LOS TRES AMIGOS NUMBER ONE SUBDIVISION

APPLICATION NUMBER Holdover DATE May 3, 2007

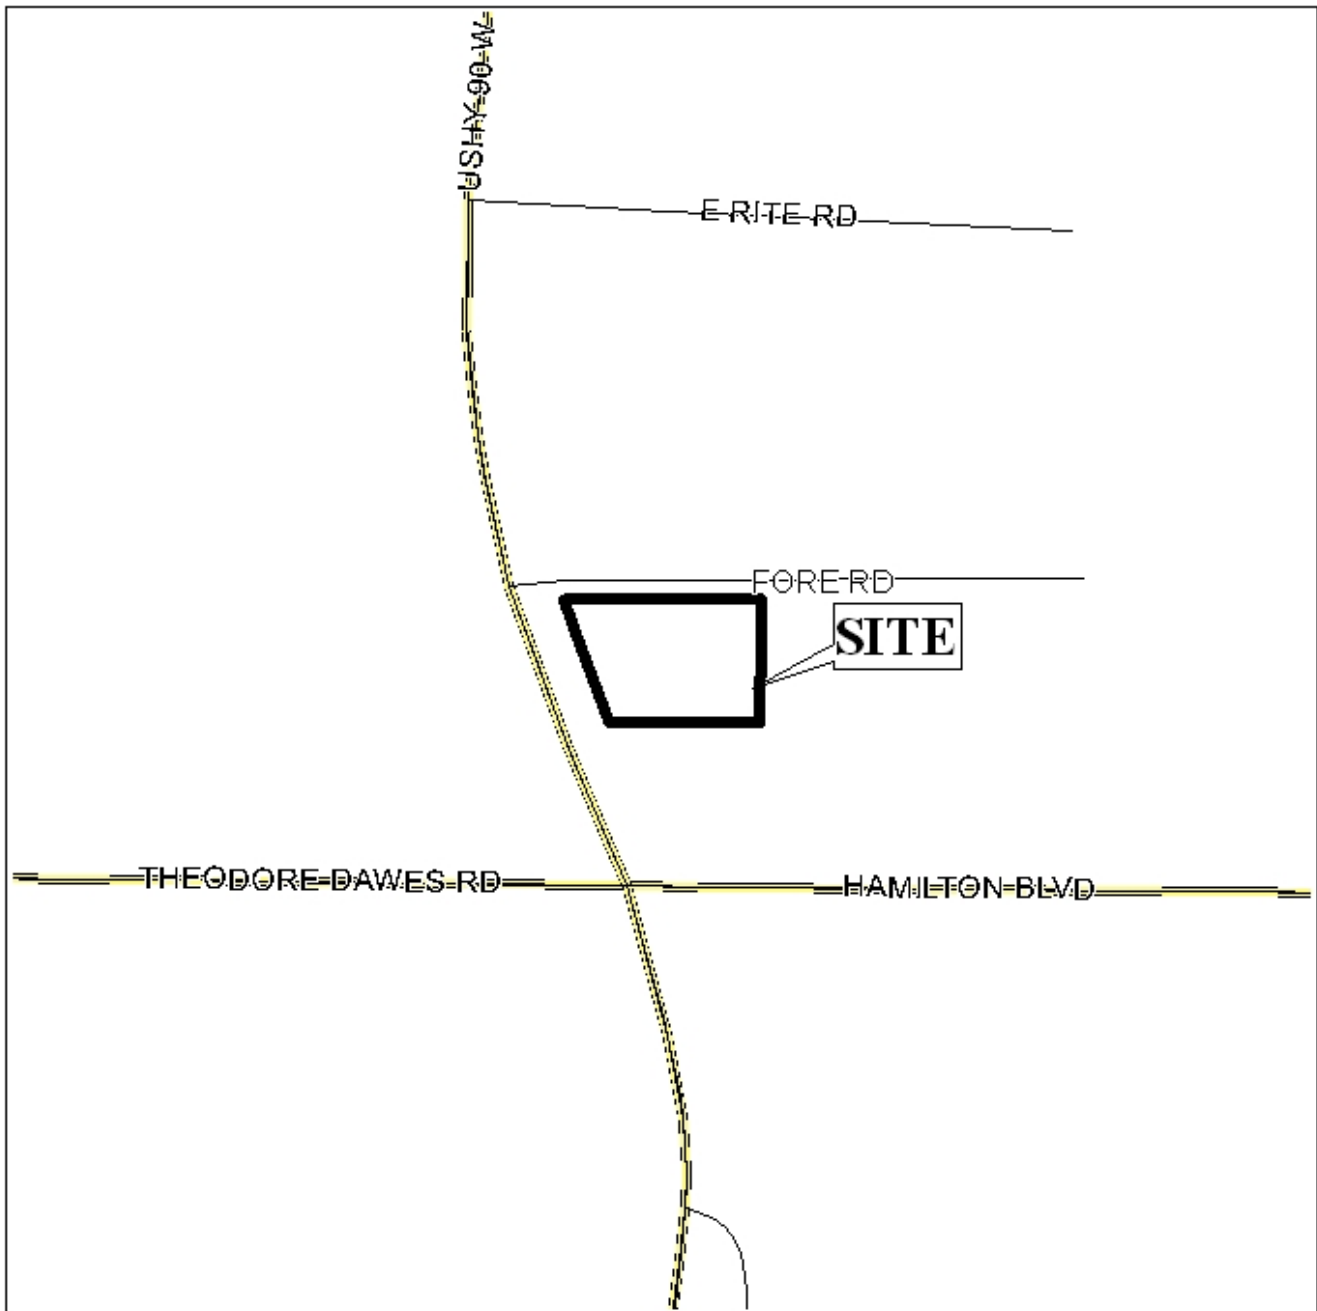
The purpose of this application is to create a 1-lot subdivision from a metes and bounds parcel. However, as illustrated on the Vicinity Map there is a land-locked parcel to the rear of the proposed preliminary plat. It appears that the land-locked parcel was created after 1984, but without going through the Subdivision process. Therefore, the parcel should be included into the proposed subdivision.

The site fronts U. S. Highway 90, which is shown as a major street on the Major Street Plan component of the Comprehensive Plan; and as such, requires a minimum right-of-way of 250-feet. The plat does not indicate the existing right-of-way width along the site. Therefore, dedication sufficient to provide a minimum of 125-feet from centerline should be required.

As U. S. Highway 90 is a major street, access management is a concern, a limitation on the number of curb cuts would be appropriate. Given the amount of linear frontage as illustrated (255-feet) and the proposed configuration, a maximum of two curb cuts, with the size, location and design to be approved by County Engineering and ALDOT should be required. Additionally, as the site is adjacent to Fore Road which is a private road access, should be denied to this private road.

The 25-foot minimum building setback lines, required in Section V.D.9., are not shown, but would be required on the final plat.

The plat is recommended for Holdover until the May 3rd meeting, with revisions due by April 9th, so that the following can be addressed: 1) provision of documentation to show that parcel

R023802032000006.005. was created prior to 1984, or inclusion of the parent parcel and subsequent divisions that occurred after 1984 as part of the Subdivision application, with additional labels and postage as necessary.

No additional information or documentation was submitted as requested (documentation to show that parcel R023802032000006.005 was created prior to 1984, or inclusion of the parent parcel and subsequent divisions that occurred after 1984 as part of the Subdivision application, with additional labels and postage as necessary).

Therefore, the application for Subdivision is recommended for denial for the following reason:

- 1. the plat does not include all of the original parent parcel, or parcels divided after 1984, and thus is not in compliance with the Subdivision Regulations.*
